UNITED STATES PATENT AND TRADEMARK OFFICE

10/783,499

DETAILED ACTION***Claim Rejections - 35 USC § 102***

Comparison Illustration.

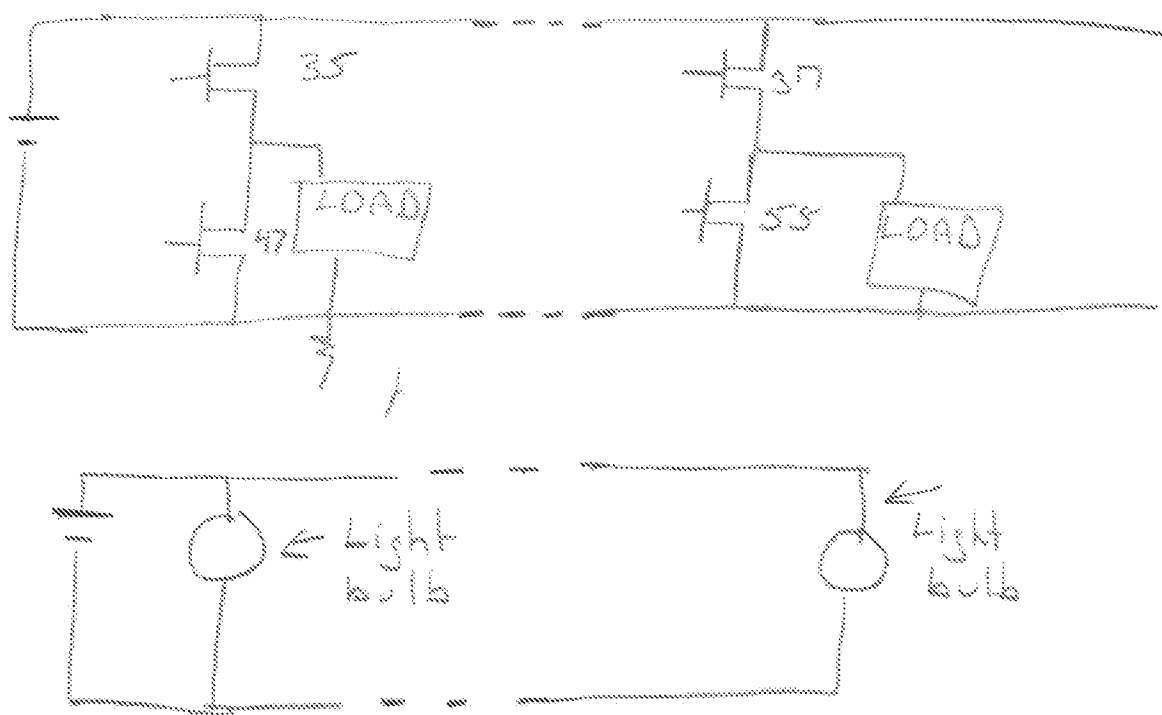
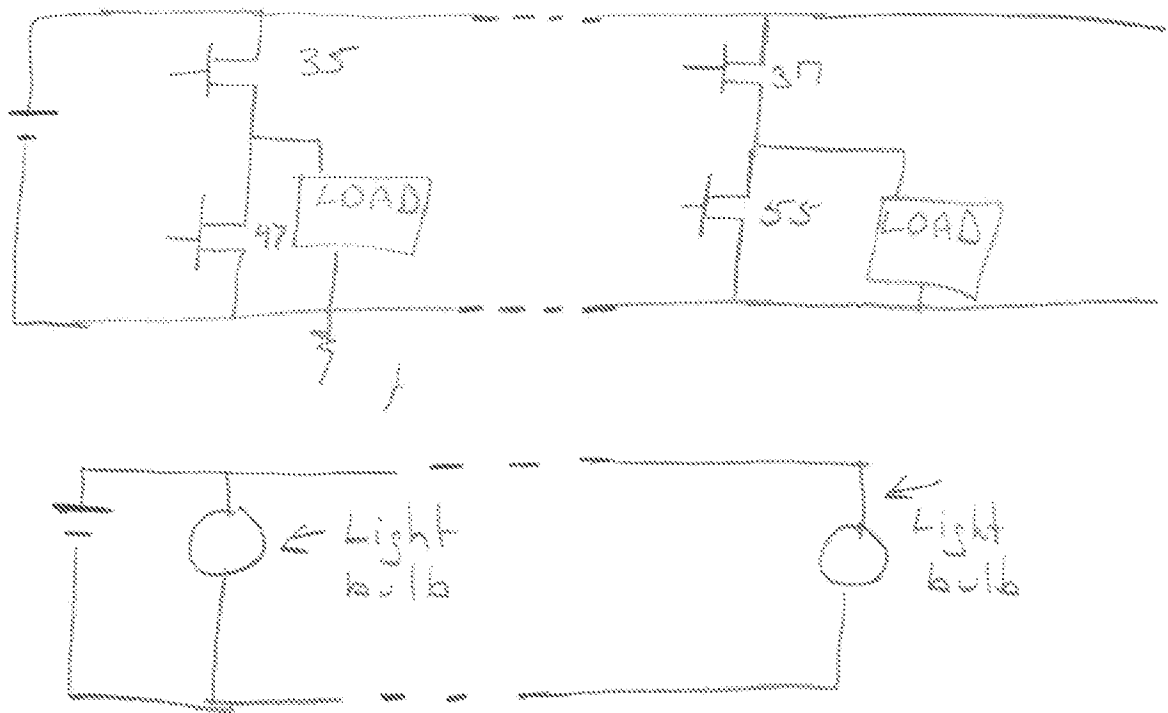
Applicant appears to make an issue of the PWM signals being "in-phase" with transistors 35 and 37 of the disclosed invention being both roughly "on" at the same time (See page 12 around line 23 of the instant application.), as compared to what might be considered "out of phase" pwm signals of the prior art where transistor 31/PWM1 is "on" and transistor 33/PWM3 is "off" roughly at the same time in the prior art. See column 7 around line 61 of Prokin., but in actuality the baseband signals of both the prior art and the present invention that are applied to their two respective loads appear to be 180 degrees out of phase and thus the instantaneous currents through the first and second reactive loads is substantially zero just like claim 1 has been amended to read (This is addressed in the rejections in more detail.). Also the fact of the matter is that at least the independent claims are just not so limited to the PWM signals being "in-phase" as apparently meant by applicant and these claims are more directed toward the description of the function of having the baseband signals applied to the two loads being out of phase with each other which the prior art clearly, i.e. inherently, includes, as is addressed in more detail in the rejection(s). As also noted the claims just do not claim the specific structure of the transistors/switches 35, 37, 47 and 55 of Figure 4A, but even if applicant did claim the specific structure of the transistors/switches 35, 37, 47 and 55 of Figure 4A the structure is the same with that of the switches 31, 33, 32, and 34 of the prior art. The

Again as stated above, the prior art has the same result as applicant's invention and as noted in the previous office action there is no difference in the inverter/load structure between the disclosed invention and the invention of the prior art. Also see the "Comparison Illustration" above. These two methods of operating, i.e. the preferred method of the prior art and the preferred method of the instant application are also looked upon as two art-recognized equivalent methods of operating the same device. Again many of the claims of applicant's invention are directed toward structure and the structure is not different between the prior art and applicant's disclosed invention. Thus this discussion between the difference between the method of the disclosed invention and the preferred method of the prior art does not have much bearing on the claims as the claims presented are not method claims but claims drawn to structure and most if not all of the claims don't even relate to the so called "in-phase" and "out-of-phase" PWM signals. However, it is important to note so as to understand the rejection and respond to applicant's arguments as these arguments are directed more toward a method and not a structure. In the disclosed method of the instant application the two baseband signals are caused to be out-of-phase by using the inverse of the baseband signal to be applied to only "one side" of the inverter structure to come up with one of the two PWM signals, i.e. the "PWM" signal. How one intends to use an old structure does not define a different or new structure. The old structure still remains an old structure. Also it has been long held that the discovery of how the prior art works does not present patentable distinction in claims drawn to structure. Also additionally as pointed out to the applicant many times in claims drawn to structure, the claims must be distinguish by structure. MPEP 2114 clearly states that "while features of

Basic Illustration 1.

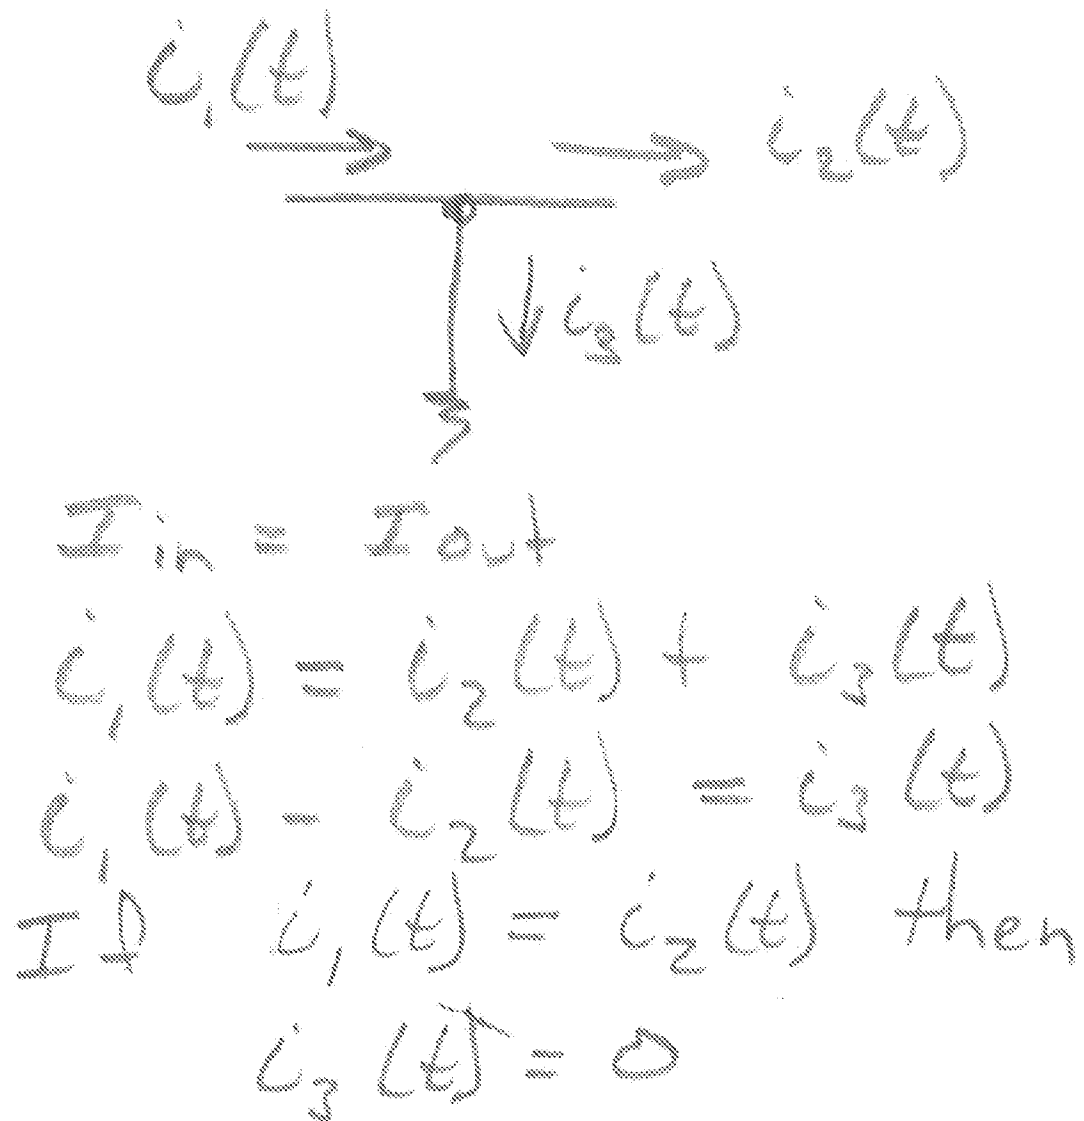
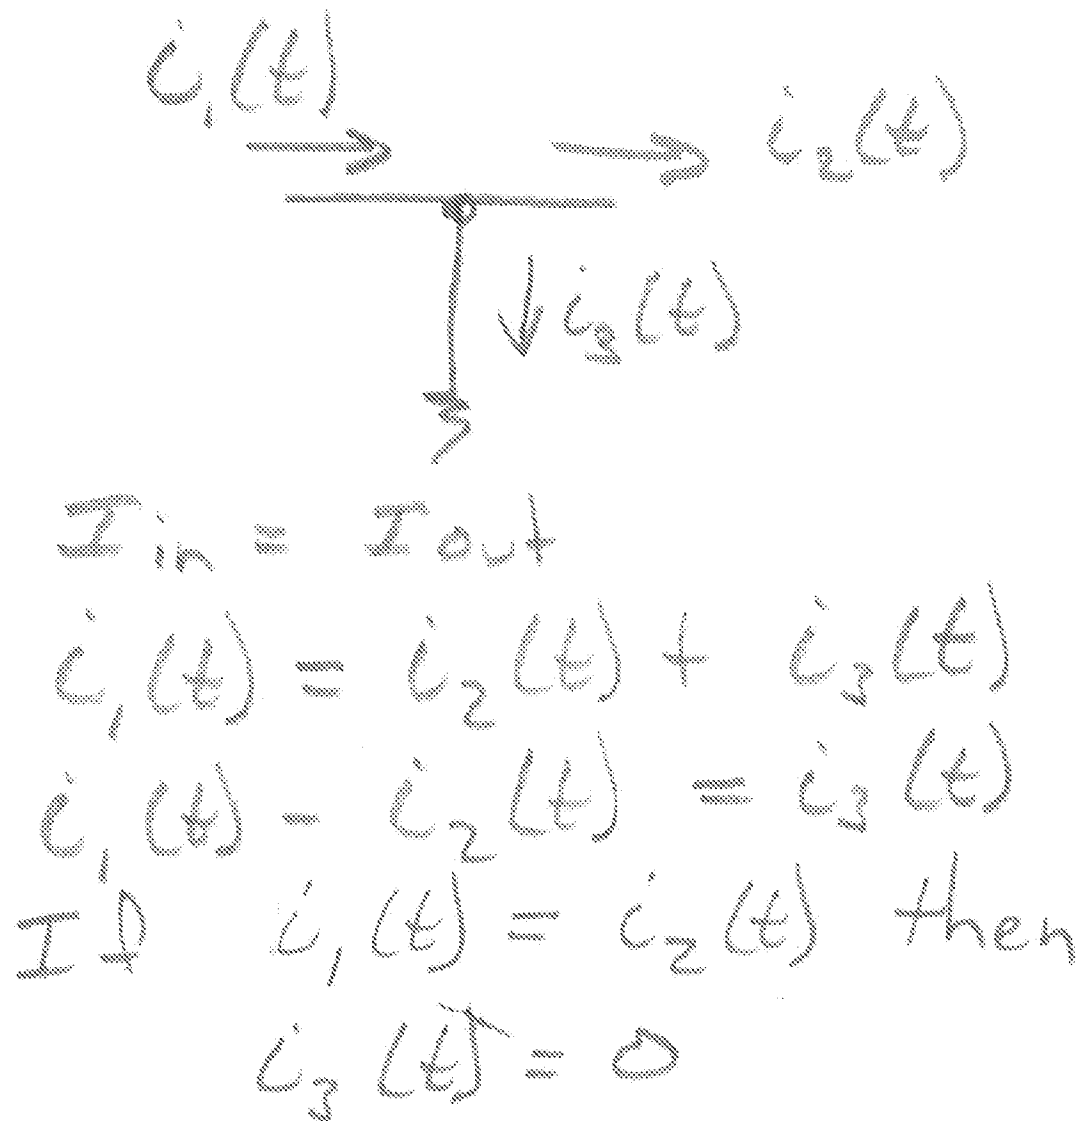
The examiner also feels that it is necessary due to applicant's remarks/arguments and to make clear to others some basic engineering features involved. It is just a common fact that in circuit analysis that a DC source acts as a short to an AC signal. So applicant's invention is more in tune to two separate push-pull or inverter arrangements that share a common ground. This is like separate light bulbs connected in parallel. Prokin also recognizes this fact in its illustration of Figure 11. The illustration below illustrates the basic arrangement of both Prokin and applicant's invention. See Basic illustration 1.

When the baseband currents are equal and opposite through the two loads then there is no baseband current through the “ground lead” as illustrated above. This is what occurs in Prokin and is the subject of the alternative description of the same function of the invention as presented in claim 9 and compared to claim 1. This fact that there is no current is based on the fact that the current into a node must equal the current out of the node, a basic engineering feature. With this then what flows into this node from one load is the current that flows into the other load. Again this is what happens in Prokin as

Speaker illustration number 2.

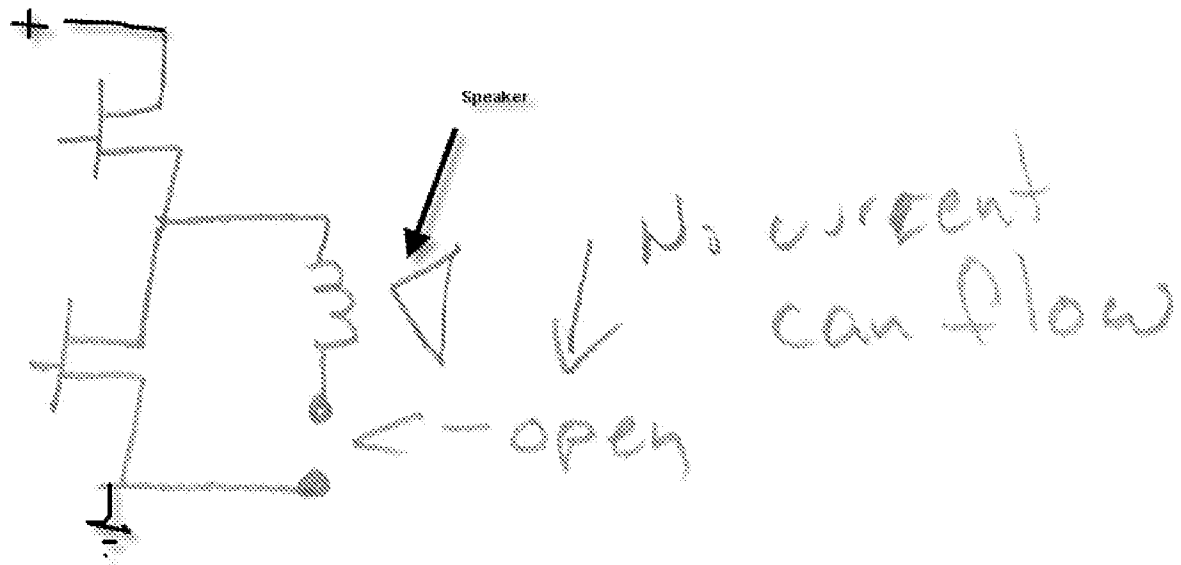
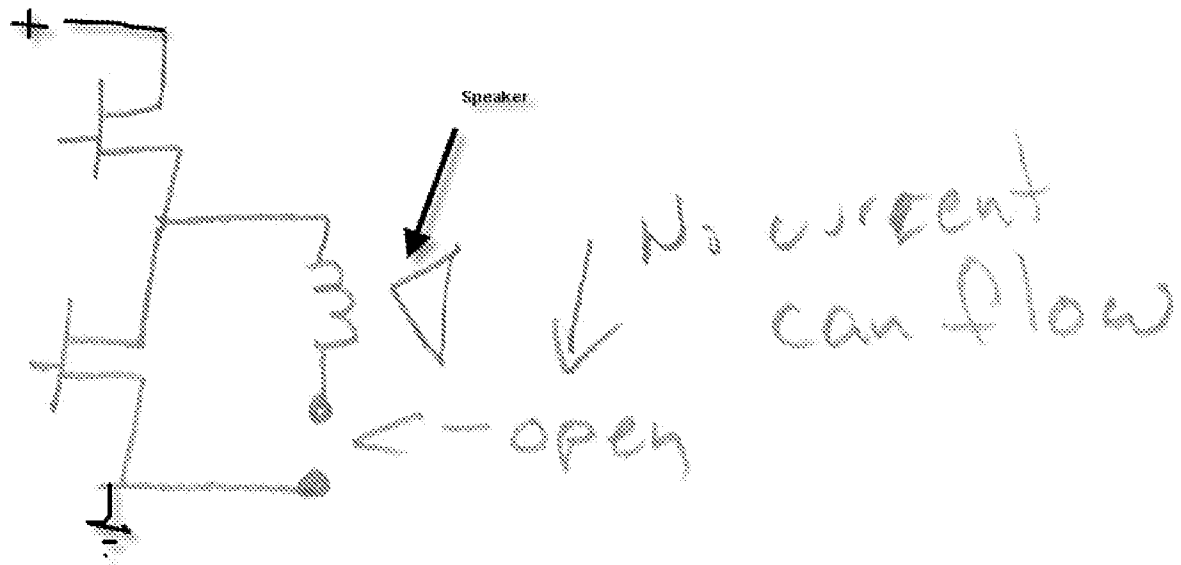
will be discussed in more detail below. Also note that if the DC source did not act as a short to AC, but as an open circuit then it would be impossible for the basic inverter or push pull unit like that of applicant's invention and that illustrated in Figure 11 of Prokin to have a return current path and thus the speaker would not speak or work. See Speaker Illustration number 2.

Figure 4a of the instant application.

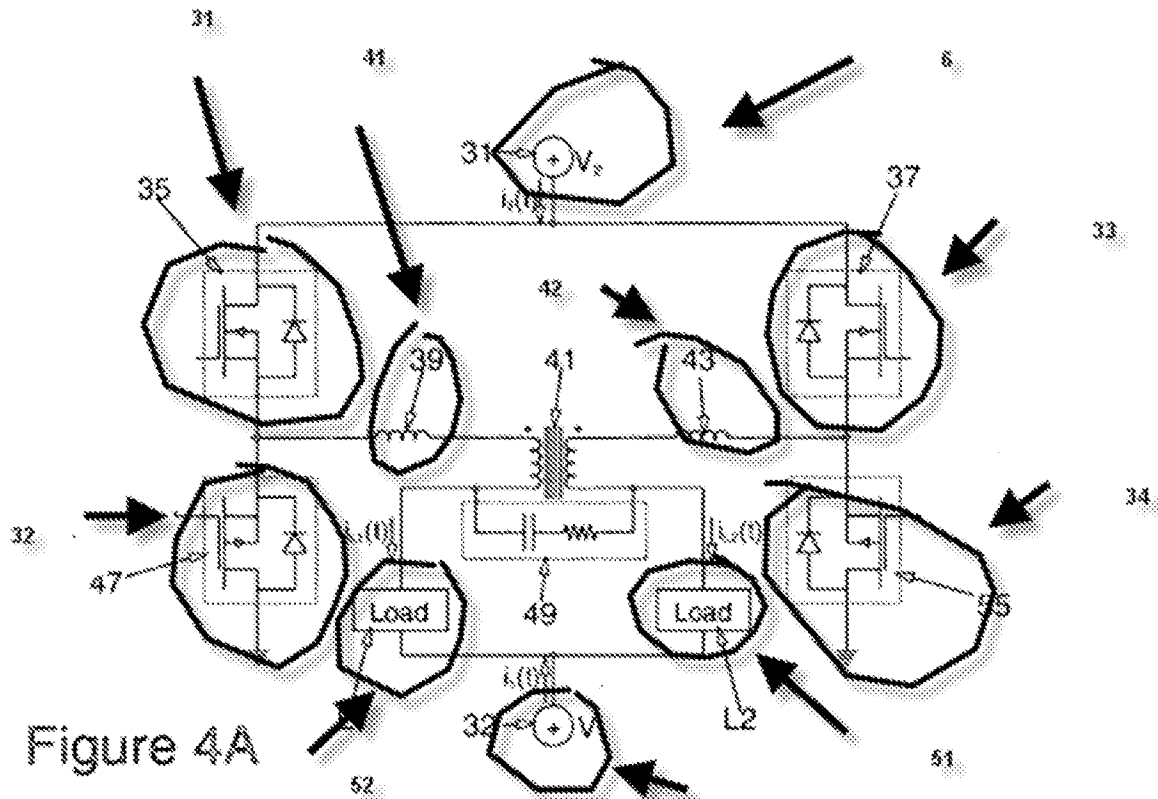
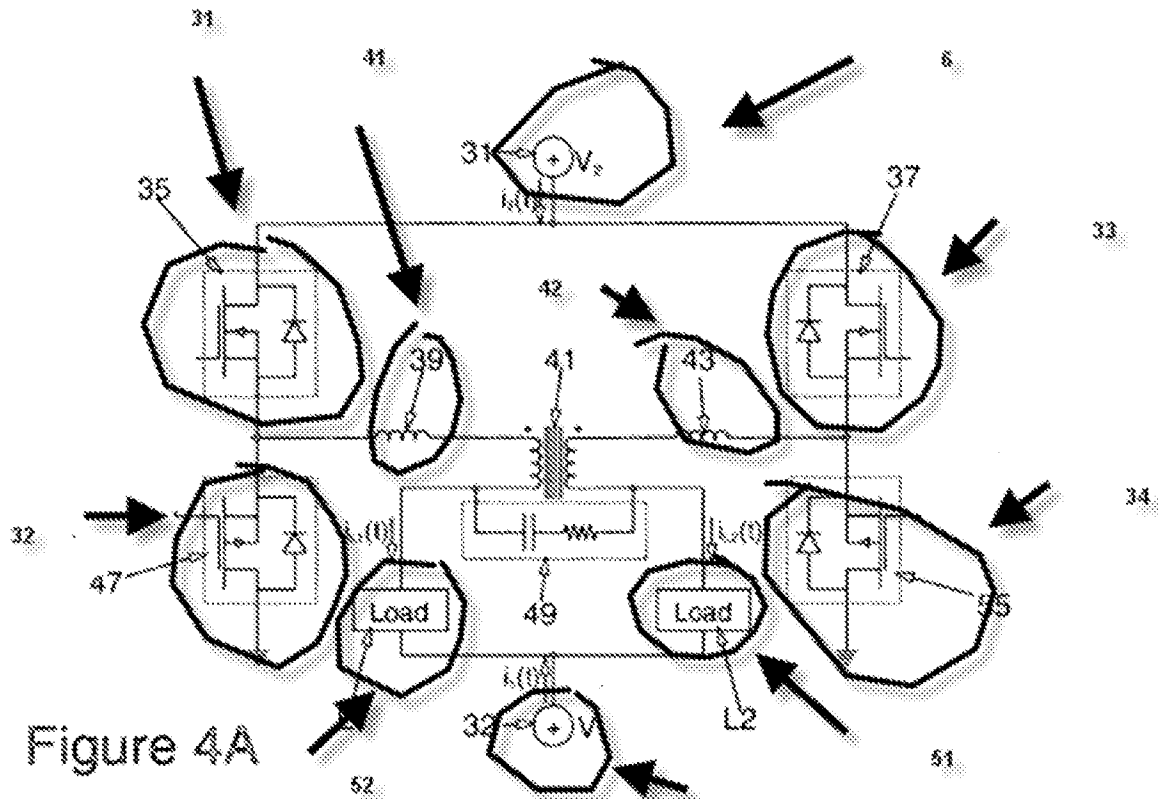
See elements 31 and 32 are part of the means that forms a first switching signal and elements 33 and 34 that forms a second switching signal of Prokin. Compare that to the disclosed invention of Figure 4a. The switching band component is the same as that of applicant's disclosed invention and that is a square-wave and as mentioned above the device of Prokin is for an audio function (It is to power voice

coils.) wherein the baseband component is applied by the pulse width modulation of the square-wave just like that of applicant's disclosed invention. (See Figure 4a of the instant application and Figure 15 of Prokin.)

Figure 15 of Prokin.

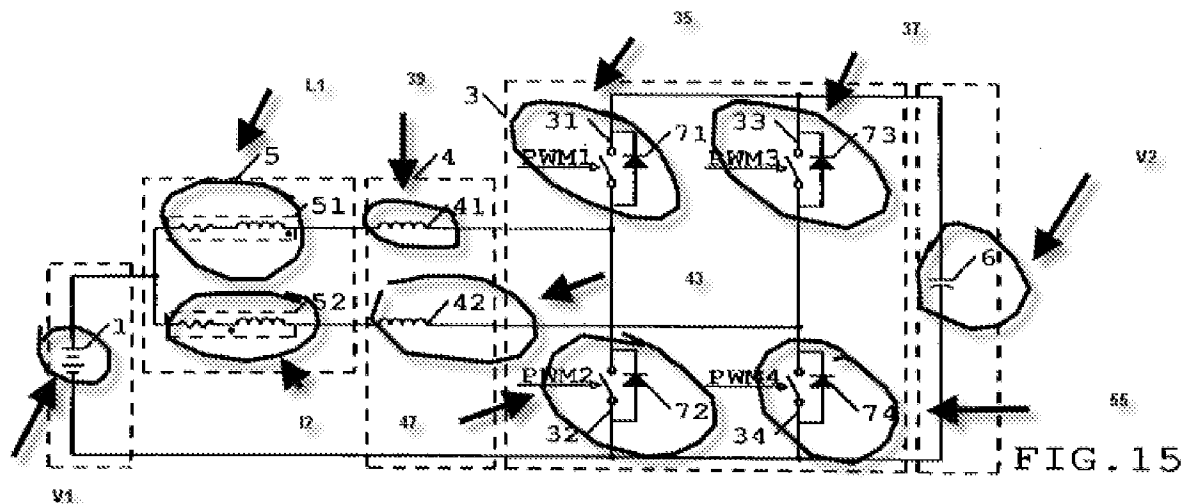
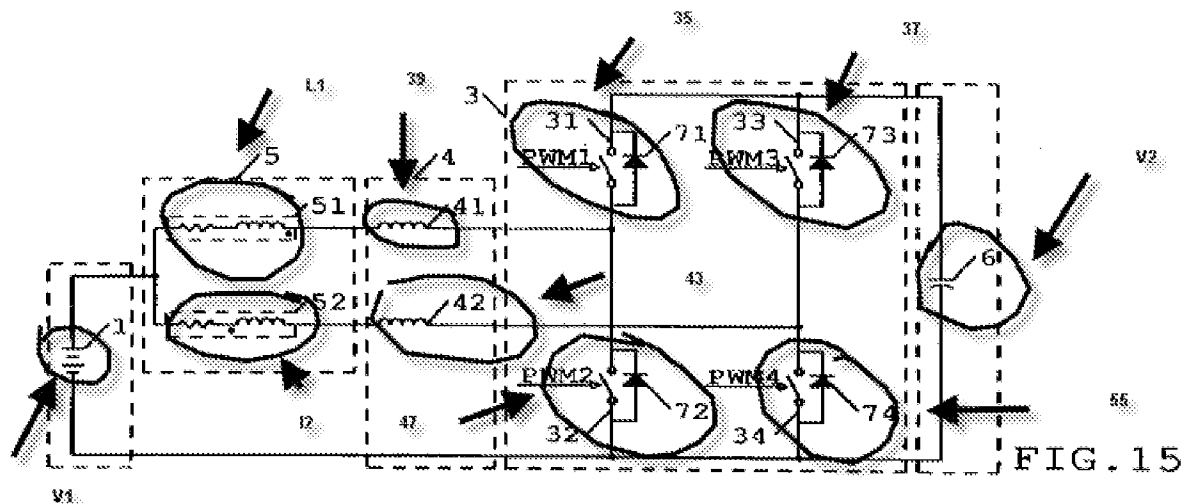
Above shows the elected invention of Figure 4a. The interconnected load for the switching amplifier is shown above. While the claims lack any detail of the switching amplifier (Just now referred to as just "apparatus" in some of the claims. The examiner has cited Prokin of record for the switching amplifier is the same as that noted above. Below the examiner has provided a copy of Figure 15 of Prokin.

As recited by Prokin the bridge capacitor 6 supplies the power for the switching amplifier (See the abstract and the relevant text in the specification of Prokin.). As one can see from the above drawings the switching amplifier of Prokin is the same structure as that of applicant's elected invention. Note the four transistors. Thus the claimed structure to the switching amplifier is anticipated by Prokin in so far as the claims are understood. Note that the switching amplifier has output lines to the interconnected load and thus these are means for applying the baseband components. Note the common power supply node of element 1 of Prokin. Note that the switching amplifier of Prokin has "at least one power supply terminal" in the bridge capacitor or element 1 as set forth by at least claim 14. The four transistors like that of applicant's four transistor structure switching amplifier produces an alternating polarity of currents (See claim 22 of the instant application.). The use of PWM signals do not define any switching amplifier structure but never the less Prokin has PWM signals applied to the four transistors that make up the switching amplifier structure. The output lines are the means for supplying the two switching signals to the interconnected load (See claim 24 of the instant application.) As stated in the previous office action, if one were to connect the interconnected load to the switching amplifier of Prokin this would result in the combination functioning exactly as that of applicant's combination of switching amplifier and
